Mountain Valley Pipeline Project

Resource Report 10 – Alternatives

FERC Environmental Information Request for Resource Report 10 Dated March 13, 2015	
Request	Location in Resource Report
1. Include a map illustrating the locations of existing pipeline systems, existing electric transmission lines, and existing major highways in the region (West Virginia and Virginia), and explain if the Mountain Valley pipeline could follow all or portions of those existing rights-of-way as route alternatives.	Appendix 10-A Figure 10.5

U.S. Environmental Protection Agency Comments on Resource Report 10

**Figure 10.5-3
Supply Header
Collocation Alternative**

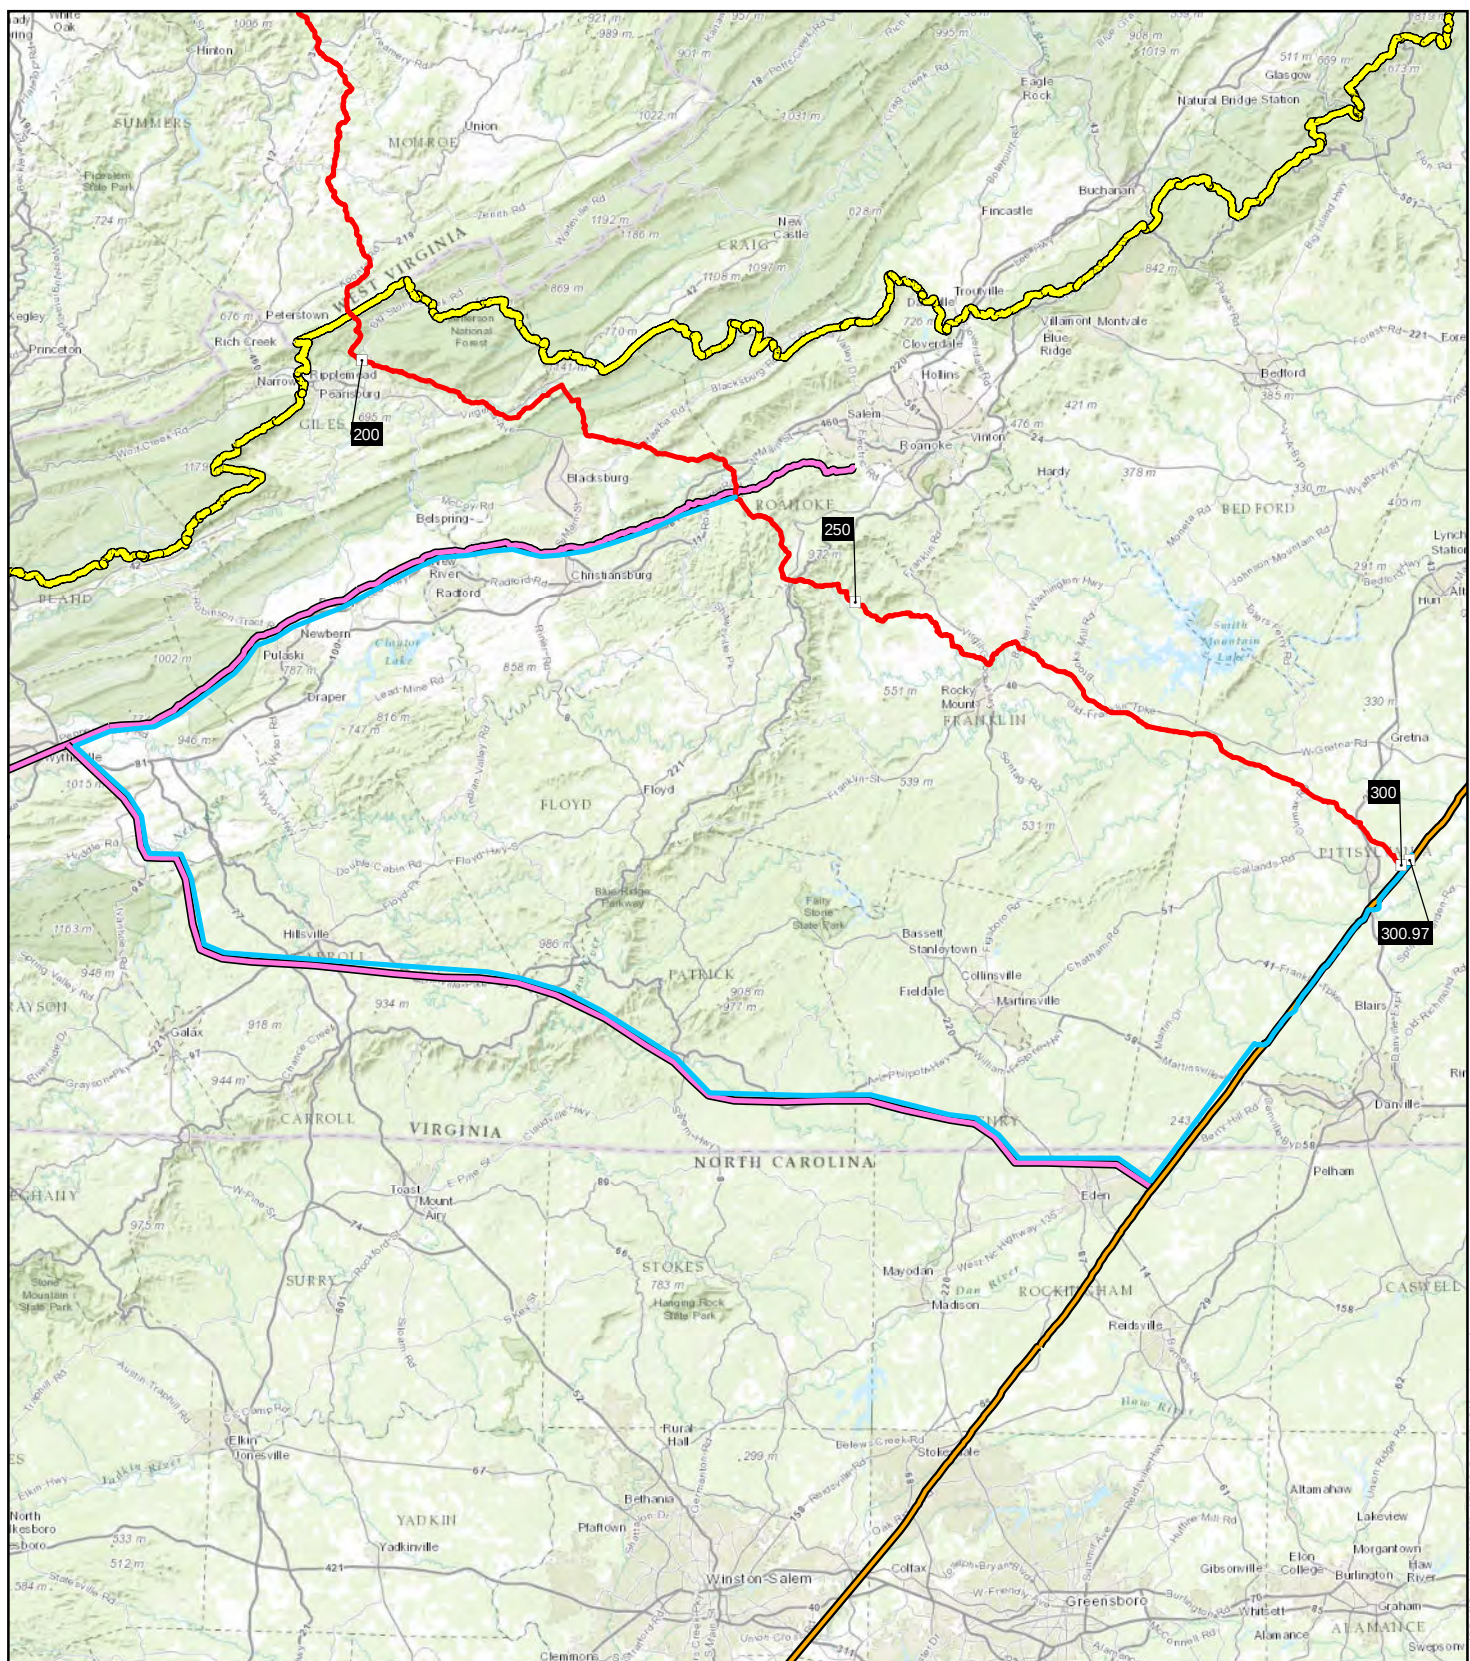
9. Revise figure 10.5-3 to depict the latest route of the proposed Supply Header pipeline, in addition to the proposed Mountain Valley pipeline route, and the Supply Header Collocation Alternative.	Appendix 10-A, Figure 10.5-3

Figure 10.6-7
AEP-Newport Variation

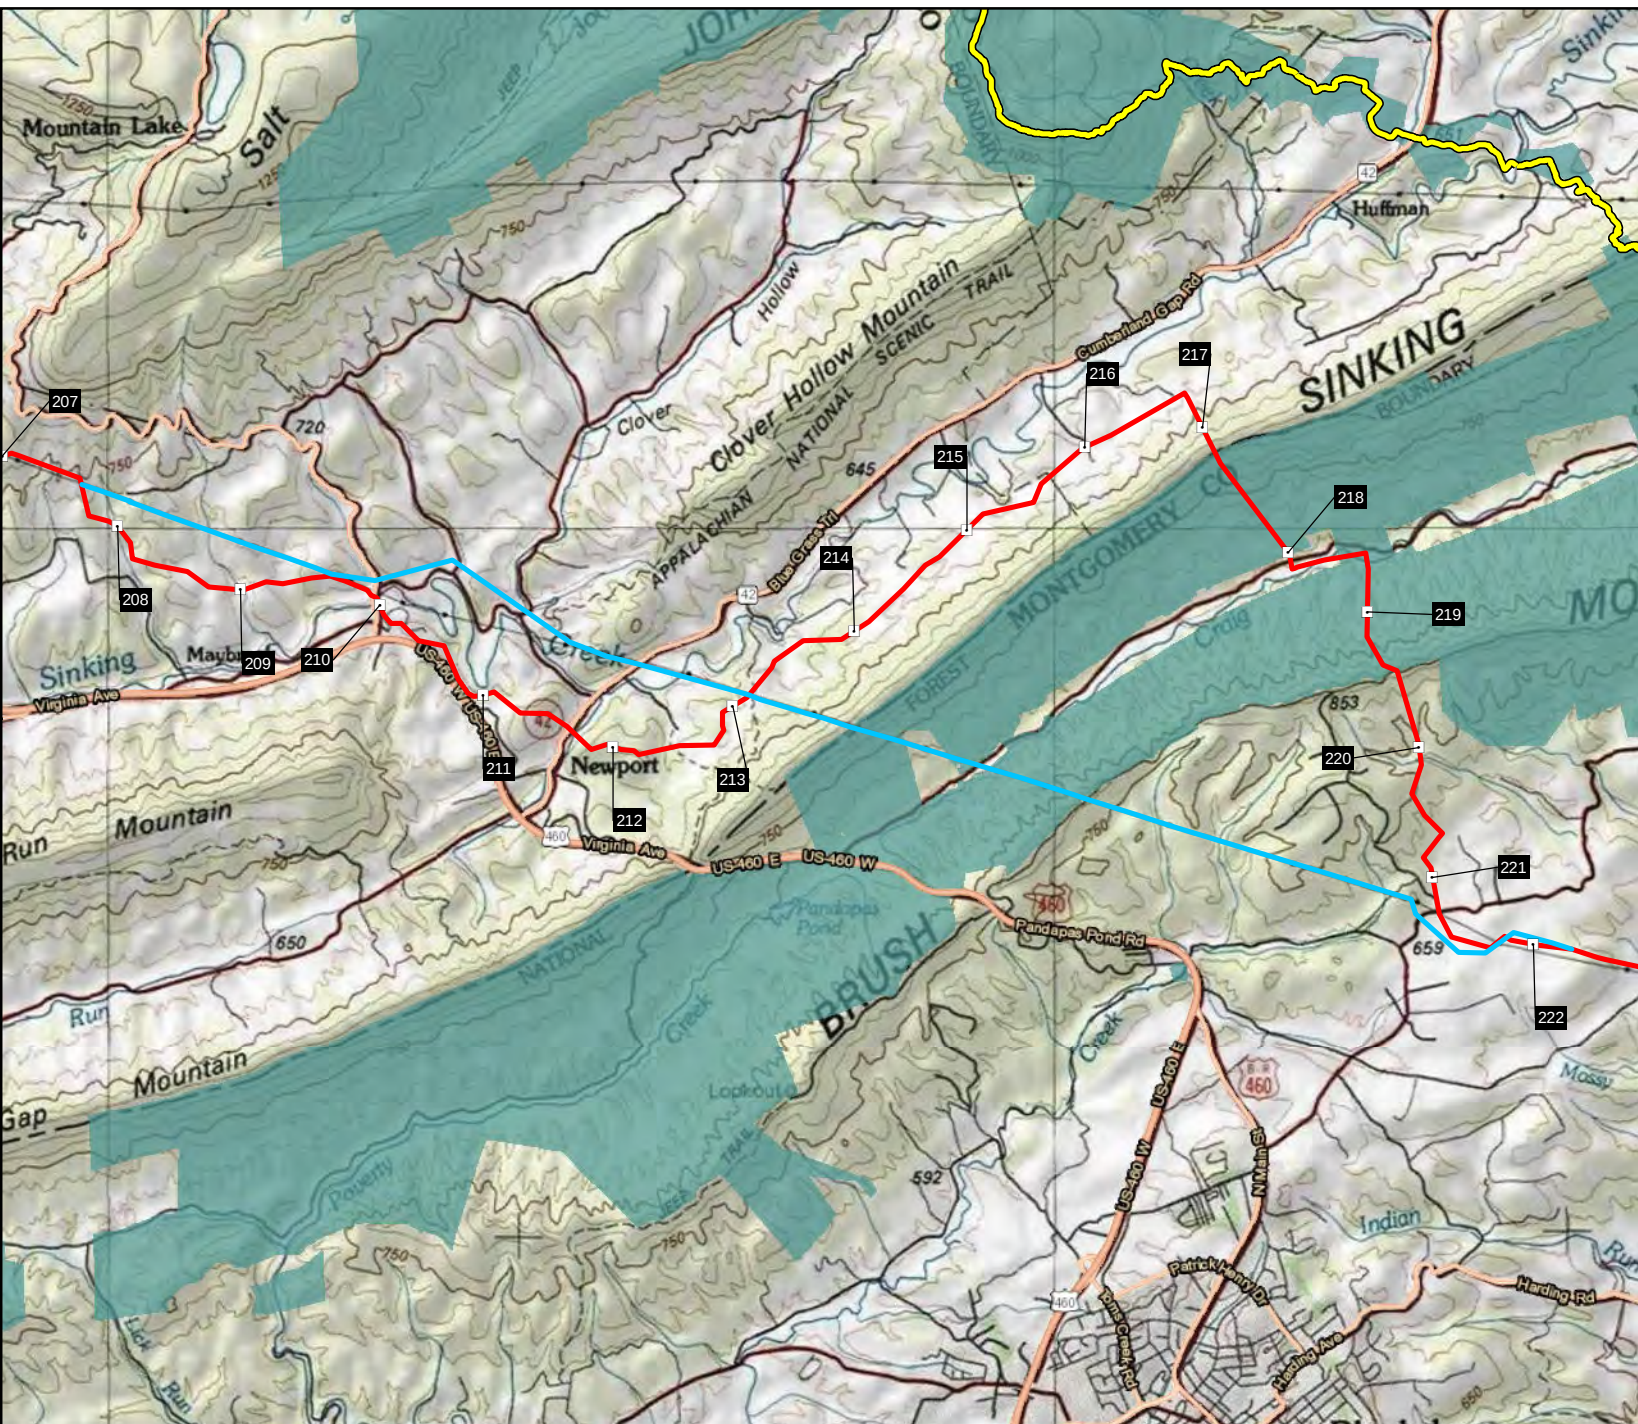
Page/Section	Request	Location in Resource Report
General (Continued)	• Peters Mountain Variation. Figure 10.6-7 should include the labels for Peters Mountain Wilderness and the Appalachian National Scenic Trail. • Alternative 93. The final resource reports should clarify the need to impact additional NFS lands, as would result under this alternative. Concerns of the FS for this route are similar to the FS's concerns to the Proposed Route with respect to all non-ANST considerations for Land Use, Recreation, and Aesthetics. • Peters Mountain Variation. This alternative proposes to route portions of the pipeline within Peters Mountain Wilderness. Approval of this route within the Wilderness can only be approved by the President "upon his determination that such use or uses in the specific area will better serve the interests of the United States and the people thereof than will its denial;"¹ ¹ Public Law 88-577 (16 U.S. C. 1131-1136) 88th Congress, Second Edition, September 3, 1964

Figure 10.6-16
Columbia Gas of Virginia
Peters Mountain Variation

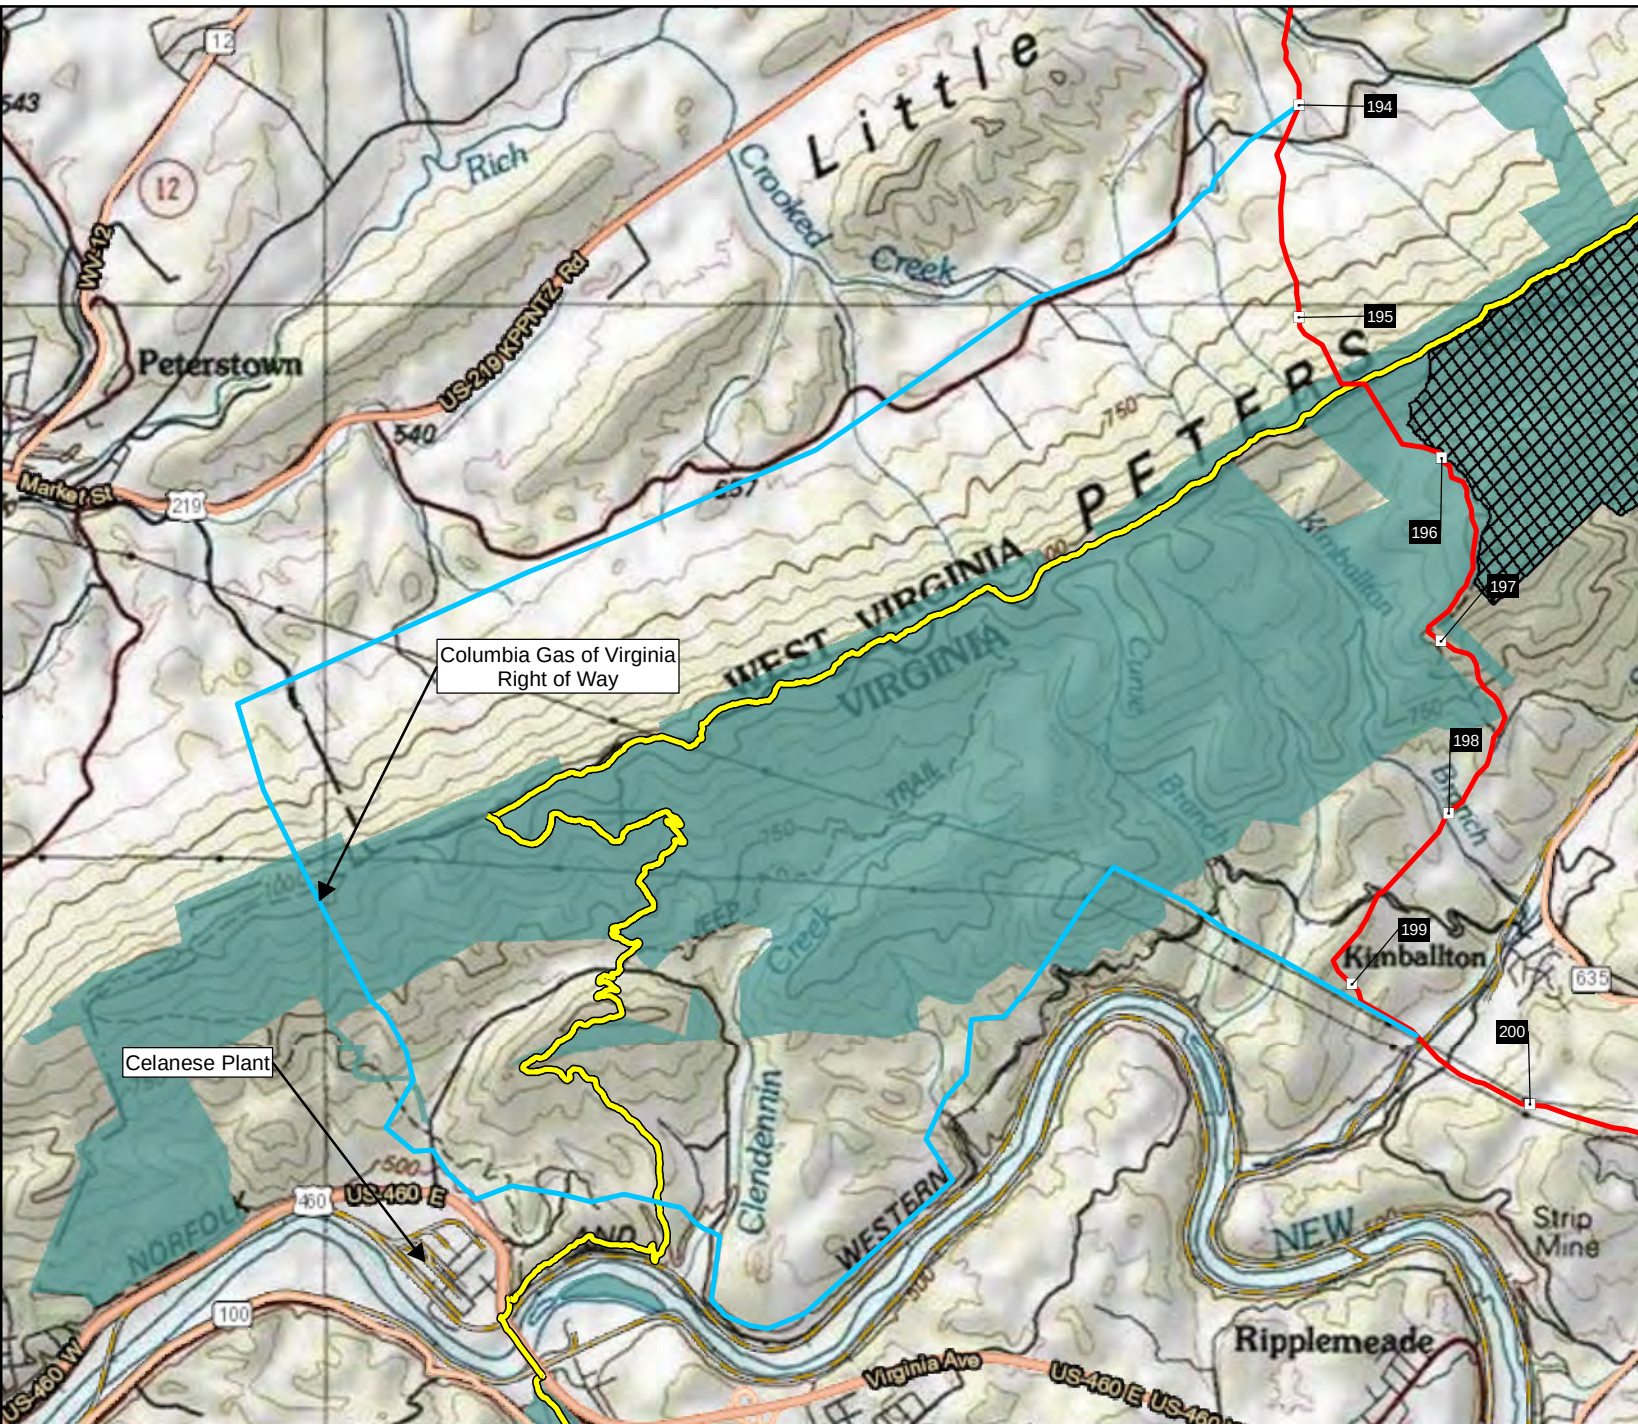
19. Include a comparison table and map for the Columbia Gas Peters Mountain Variation in section 10.6.19.	Section 10.6.16
20. Revise figure 10.6-10 to depict the boundaries of the Blake Preserve (Mill Creek Springs Natural Area Preserve).	Appendix 10-A, Figure 10.6-8
